Council Assessment Panel Agenda & Reports

15 July 2024

The Application to which the review relates is Development Application 23012613. This Application sought Planning Consent to undertake a tree damaging activity in the form of removal of a significant tree and the construction of a new carport to replace an existing carport. The nature of development was formally described as:

By DA No. 23012613 our clients sought planning consent for the construction of a replacement carport at units 6 and 7, 72-74 Queen Street, Norwood and the consequential removal of an adjacent significant tree (**proposed development**).

FLOOR PLAN OPTION B
1:100

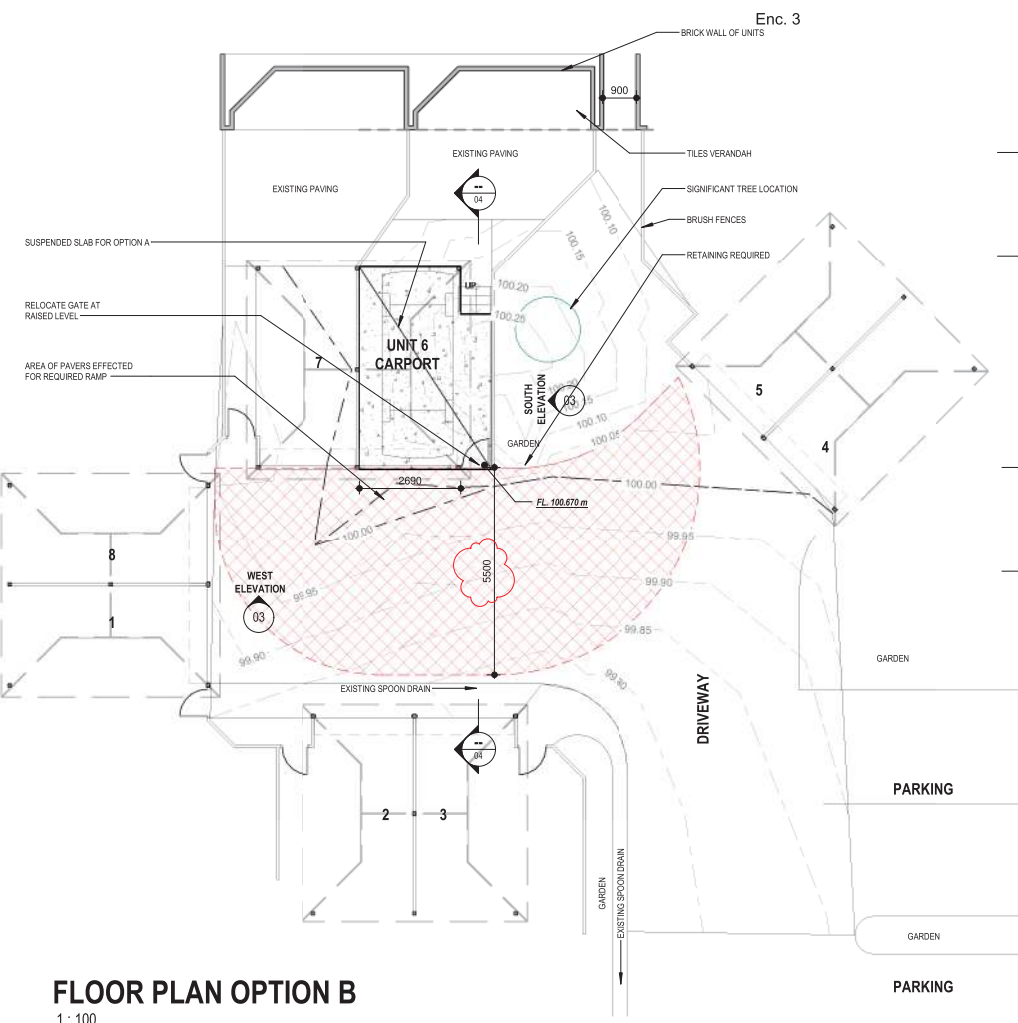
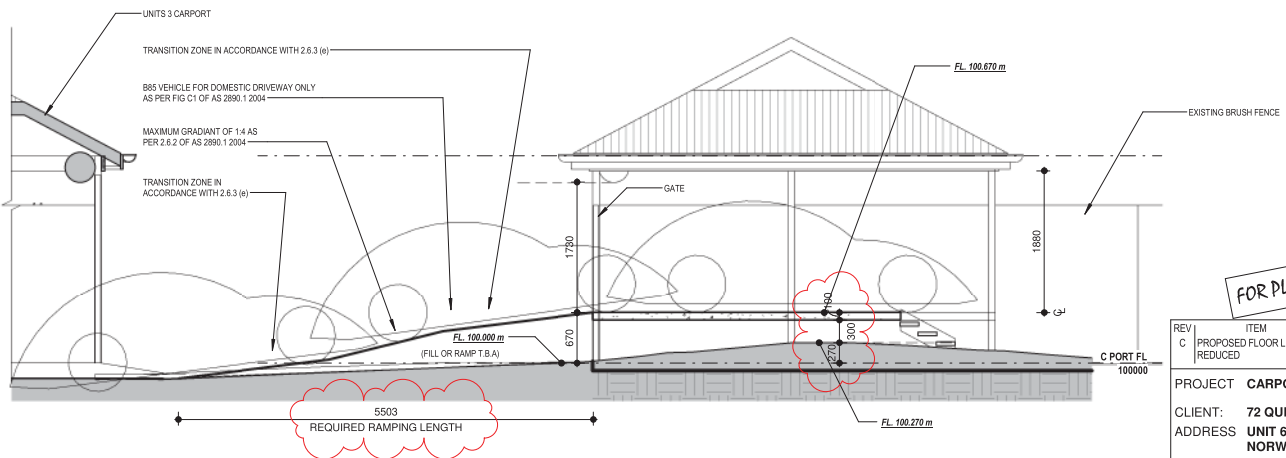
Option B is identified both in plan view (Sheet 3) and in section view (Sheet 4) of the provided plans.

SECTION OPTION A
1 : 50

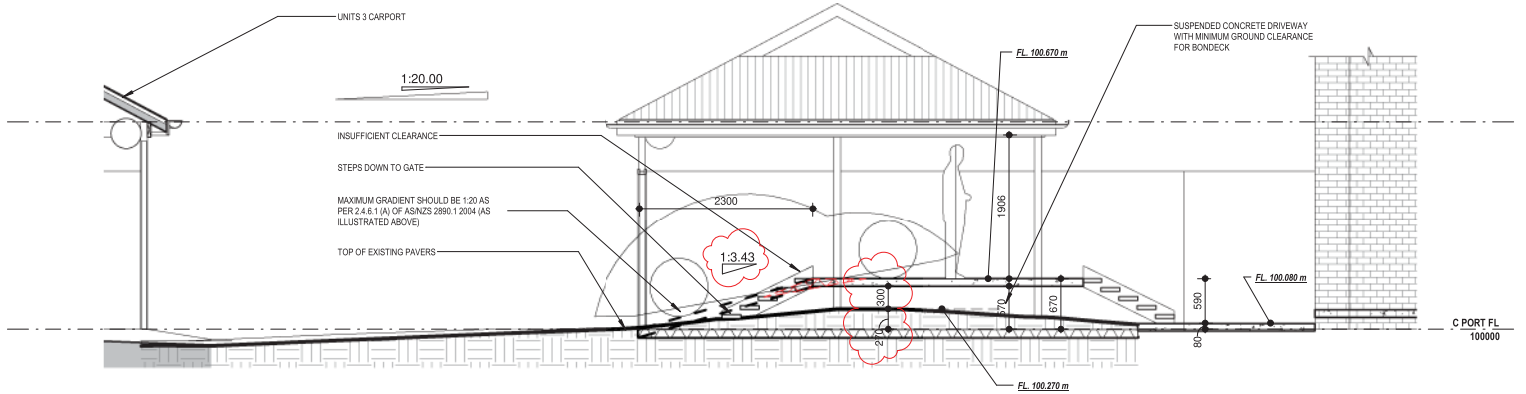
Option A is identified in the Section View on Sheet 4 of the provided plans.

FLOOR PLAN OPTION B
1 : 100

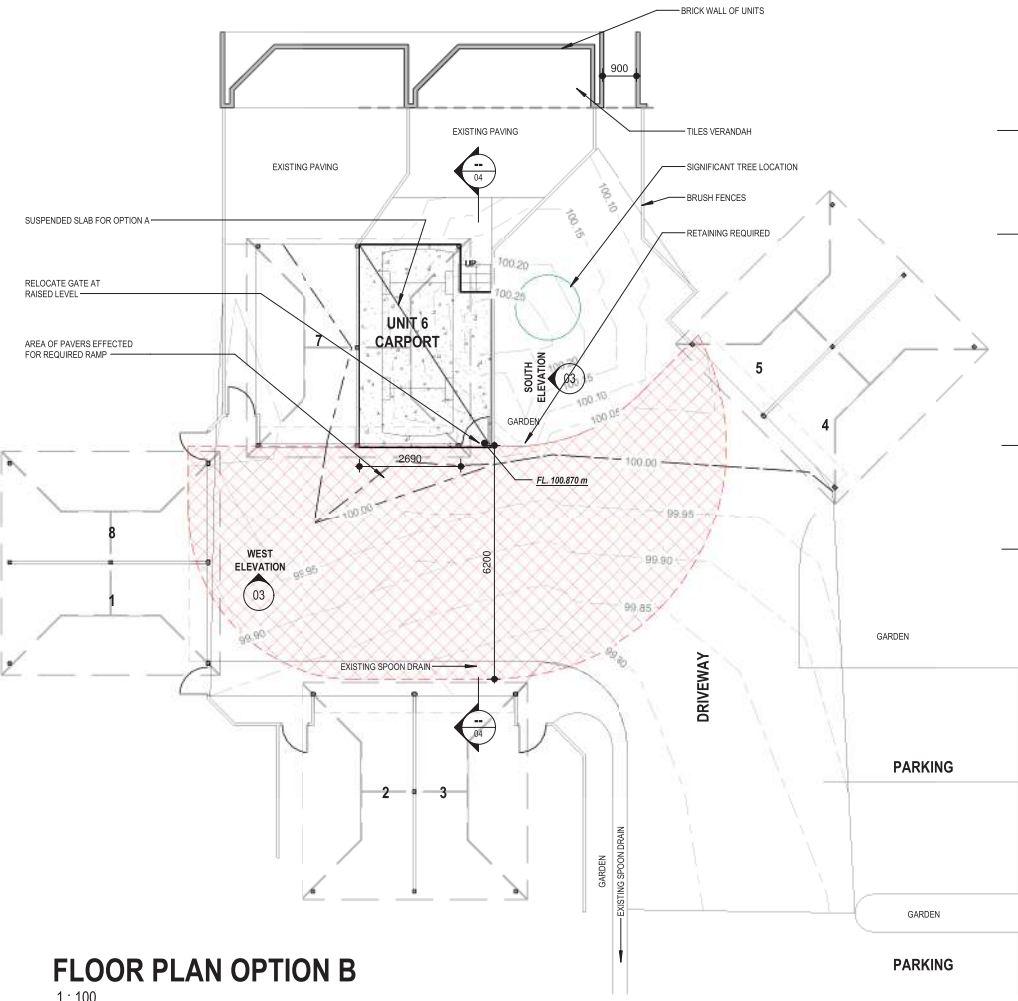
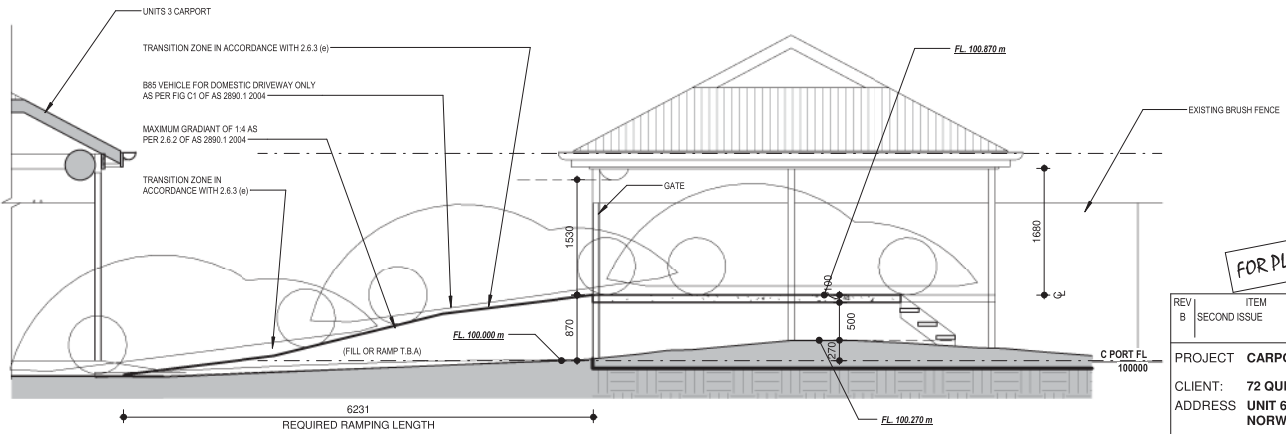
Option B is identified both in plan view (Sheet 3) and in section view (Sheet 4) of the provided plans.

SECTION OPTION A
1 : 50

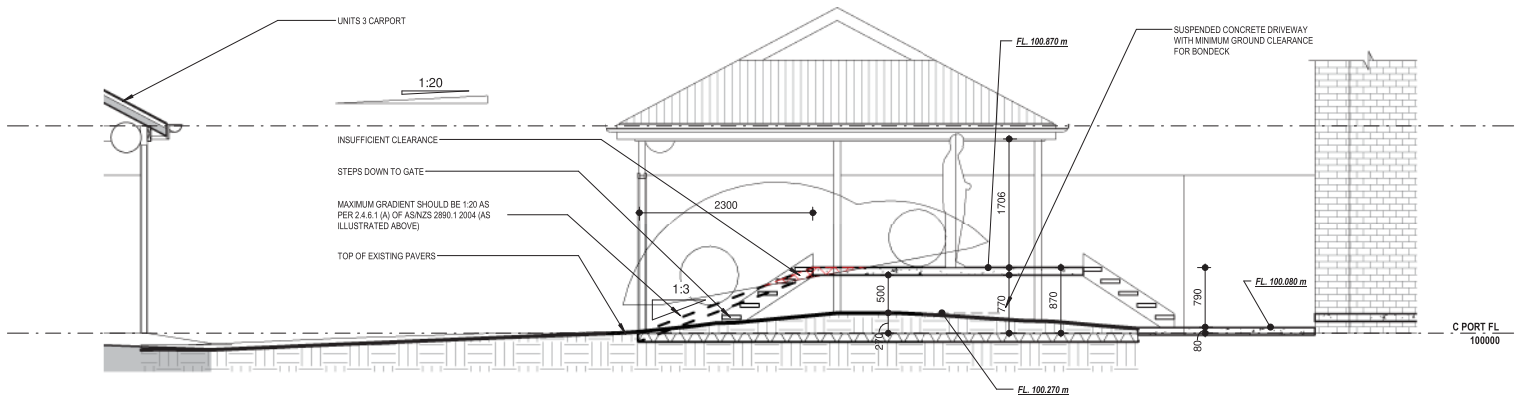
Option A is identified in the section view on Sheet 4 of the provided plans.
